Access Compliance Report

Public Rights-of-Way

(Curb Ramps)

Intersection ID: 11082	Main Street: E_35TH_ST	Cross Street: MURDOCK_RD	Location: NE
ADA ID: F81674259B2B	Ramp Type: Perp	Initial Pass/Fail: Fail	Overall Compliance: No
Severity Score: 10			
Codes/Mitigation Info/Possible Solution		Field Measurements/Component Compliance

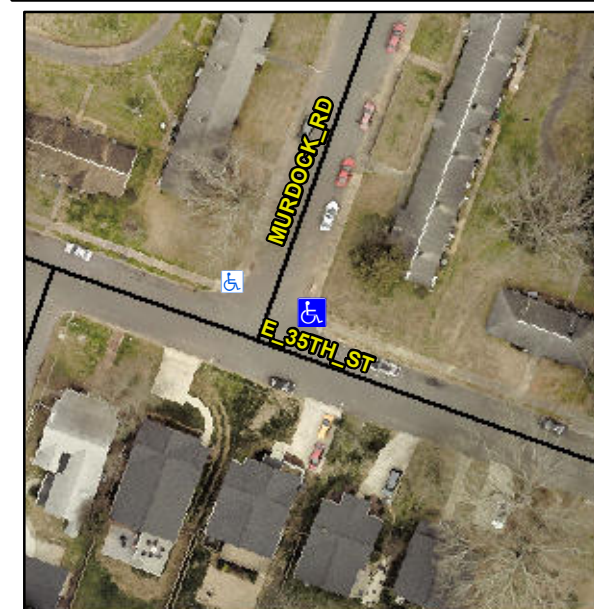
Not Found, R304.5.1, R304.5.3

Compliance	Description	Data	Compliance	Description	Data
N/A	Ramp Length (in)	59.0	Yes	Ramp Slope (%)	5.2
No	Ramp Width (in)	46.5	No	Ramp XSlope (%)	4.5
N/A	Flare Type LT	N/A	N/A	Flare Type RT	N/A
N/A	Flare Slope LT (%)	N/A	N/A	Flare Slope RT (%)	N/A
N/A	Flare Traversable LT?	N/A	N/A	Flare Traversable RT?	N/A
N/A	Landing Length (in)	N/A	N/A	DWS Provided?	N/A
N/A	Landing Width (in)	N/A	N/A	DWS Contrast?	N/A
N/A	Landing Slope (%)	N/A	N/A	DWS Length (in)	N/A
N/A	Landing X Slope (%)	N/A	N/A	DWS Full Width?	N/A
N/A	Landing Curb? (Y/N)	N/A	N/A	DWS Offset (in)	N/A
N/A	Shared Landing?	N/A			
N/A	Gutter Ponding?	N/A	N/A	Gutter Slope (%)	N/A
N/A	Gutter Lip Ht (in)	N/A	N/A	Gutter X Slope (%)	N/A
N/A	Painted X Walk1?	No	N/A	Painted X Walk2?	N/A
	X Walk 1 Direction	To NW		X Walk 2 Direction	N/A
N/A	X Walk 1 Width (in)	N/A	N/A	X Walk 2 Width (in)	N/A
	X Walk 1 Slope (%)	0.2		X Walk 2 Slope (%)	N/A
	X Walk 1 X Slope (%)	1.4		X Walk 2 X Slope (%)	N/A

Remove & Replace Entire Ramp.
